SUBJECT: Responds to NRC 871125 request for addl info re proposed
 license amend. Proposed amend to permit replacement of spent
 fuel pool racks at Unit 1 to ensure that sufficient future
 capacity exists for storage of spent fuel. Figures encl.

L-87-538

Re: St. Lucie Unit I
Docket No. 50-335
Spent Fuel Rerack

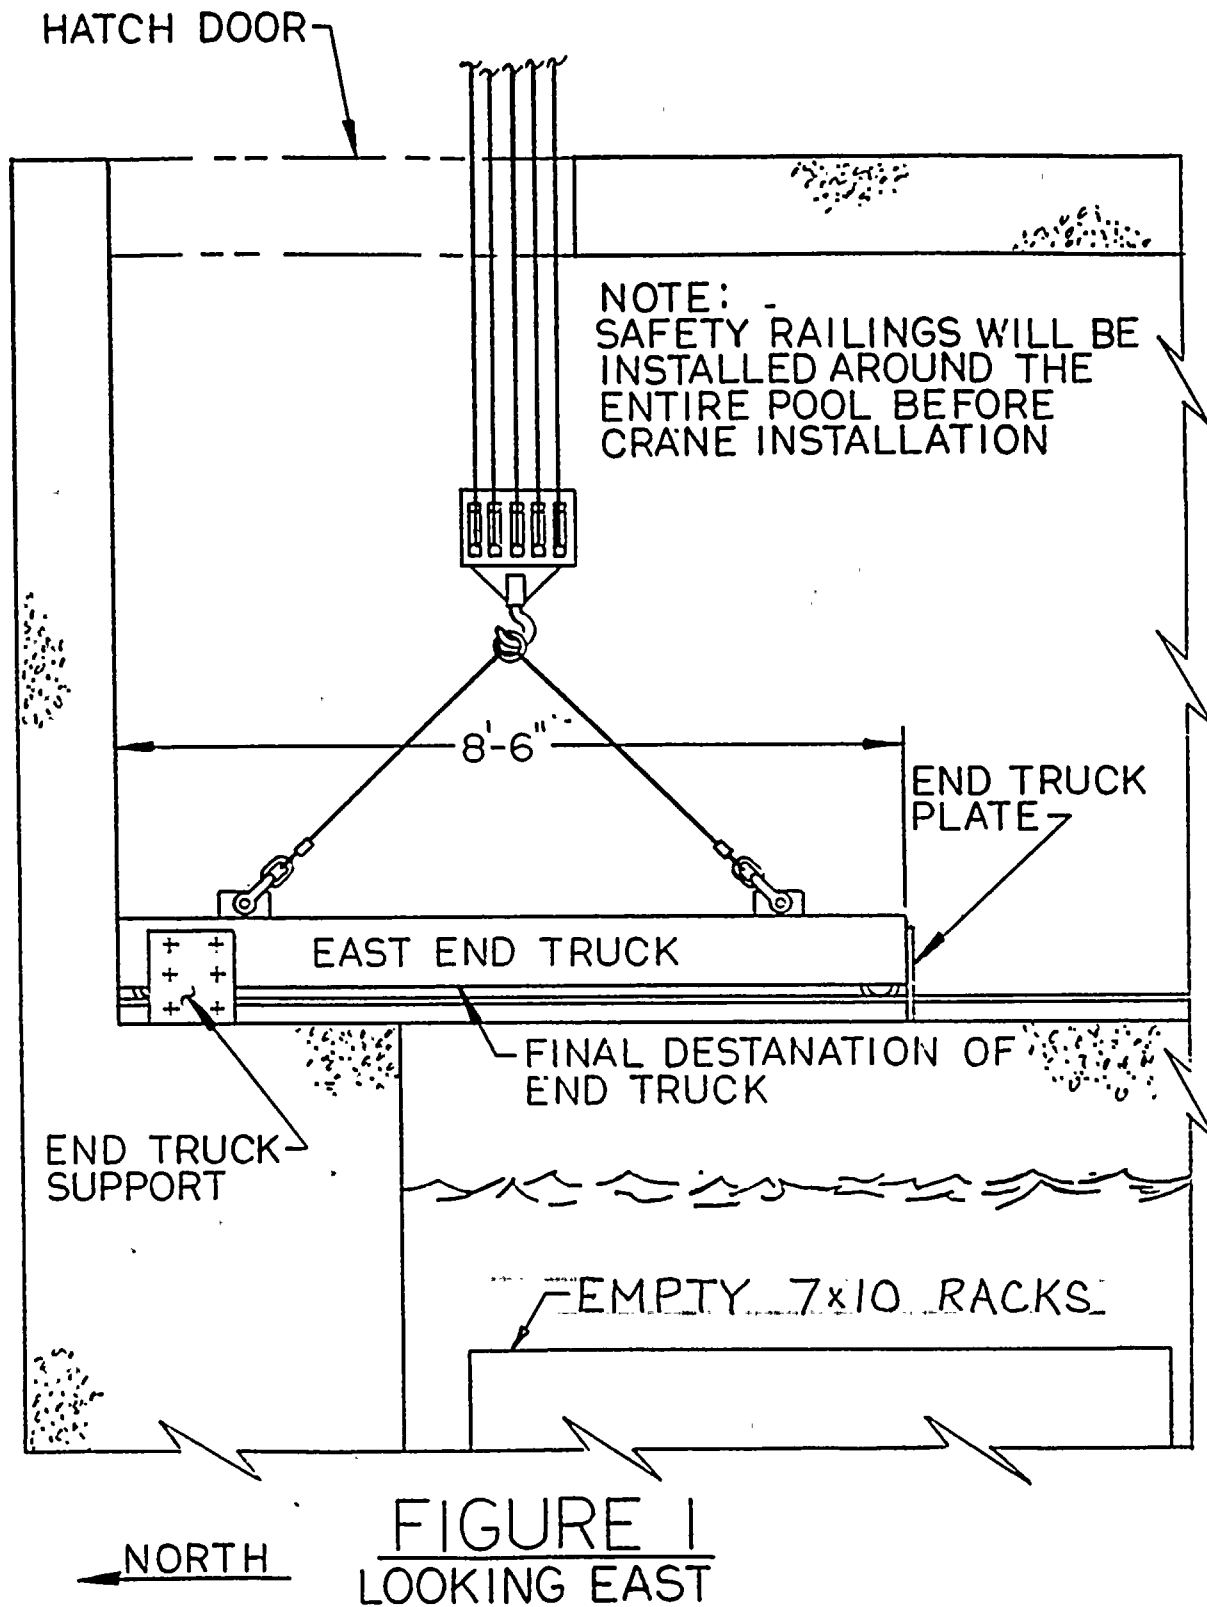
QUESTION NO. 1: Provide additional discussion on the temporary crane that will be used to handle the spent fuel storage racks within the fuel building; specifically, the load path that the fuel building crane will take to carry the temporary crane. Demonstrate that the appropriate safety factors have been applied to the crane.

RESPONSE: Figures 1 through 9 depict the installation sequence for the temporary crane. The numbers listed below correspond to the figure numbers.

1. The auxiliary hook of the fuel cask handling crane will be used to bring the east end truck into the fuel handling building. Using a tag line, the truck will be set onto the east rail and secured in place. Temporary support plates will be provided for this purpose.
